# Traffic Management Plan AC Black Elementary School

November 17, 2022

Sections "boxed" in red have been modified or removed in the TMP report dated November 23, 2022, which is the applicant's currently proposed version of the TMP.

## Traffic Management Plan

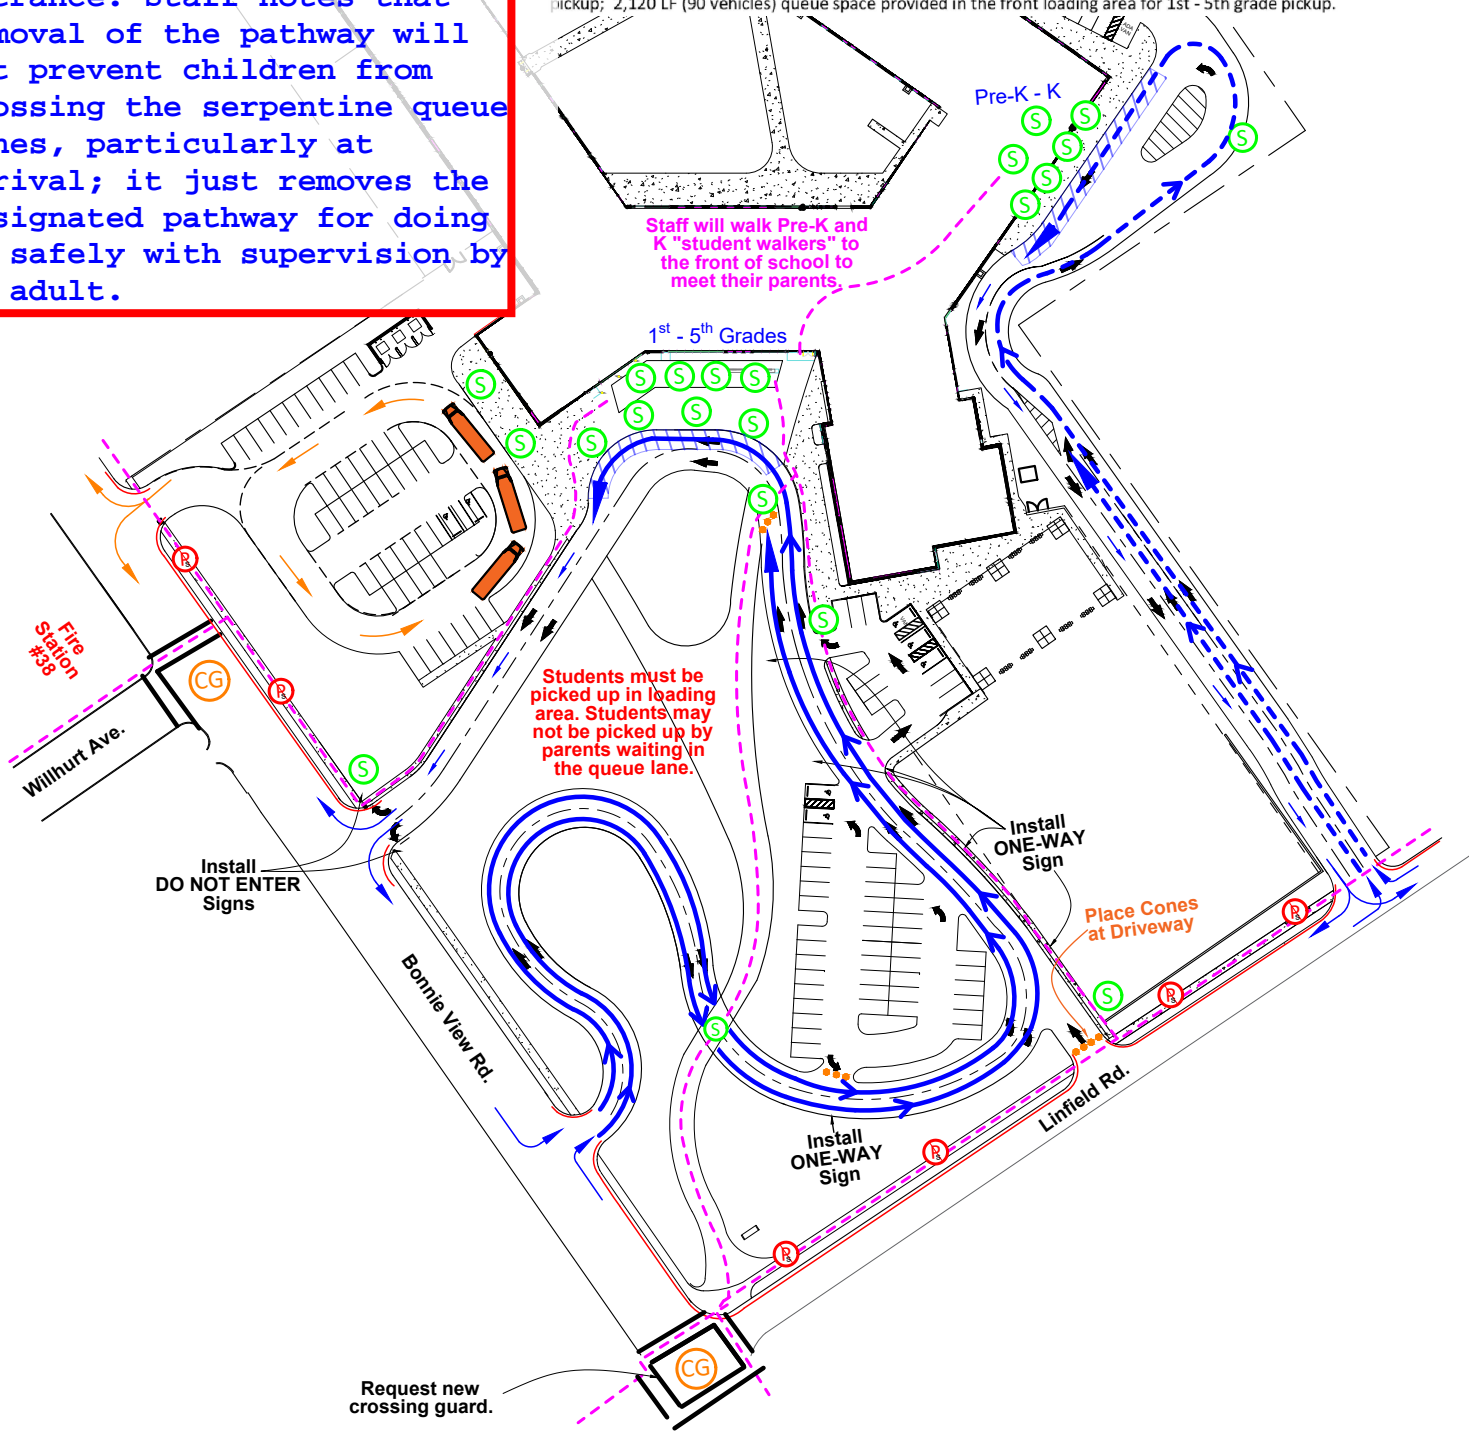
Staff recommends this version of the TMP (dated Nov. 17, 2022) and does not support the removal of the paved pedestrian path from intersection to building entrance. Staff notes that removal of the pathway will not prevent children from crossing the serpentine queue lanes, particularly at arrival; it just removes the designated pathway for doing so safely with supervision by an adult.
